# SERVICE BULLETIN

## Airspeed markings

### SB BW 6XXXX 01

#### MANDATORY

### 2.1 Garmin Reference Speed Configuration

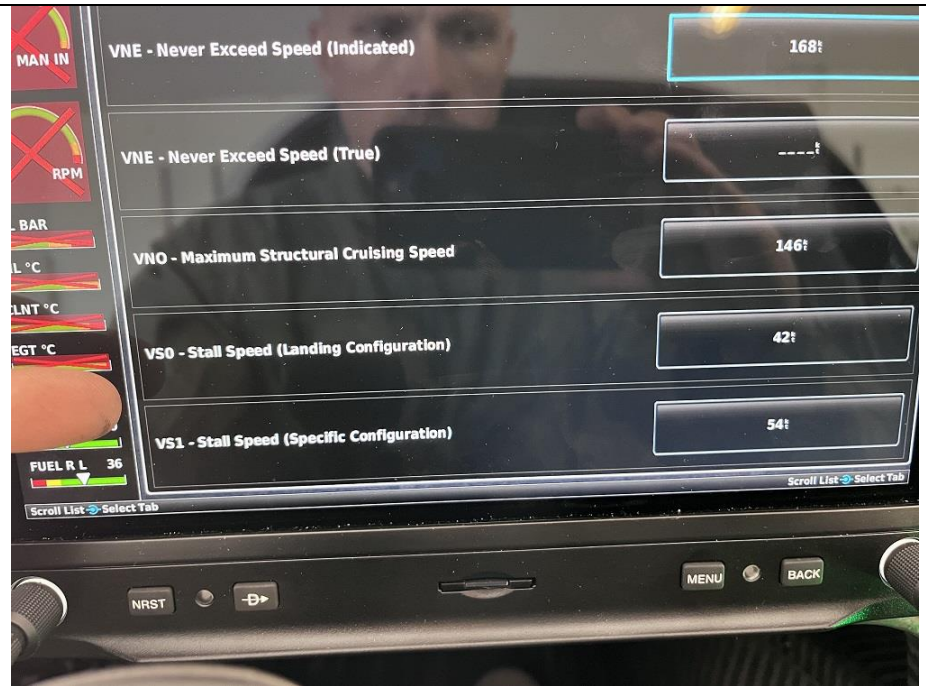
The lower end of the green and white arc for the airspeed indicator needs to be changed.

Not 10% safety margin to stall speed on airspeed markings.

Change green arc lower marking as in POH =54 kts (1.1\*49 kts)

Change white arc lower marking as in POH =42 kts (1.1\*38 kts)

Press and hold [MENU] button when powering on the Garmin G3X to enter Configuration Mode.

Scroll down to VS0 – Stall Speed and VS1 -Stall Speed. Press on the airspeed you want to change.

Input the new value and press [Enter].
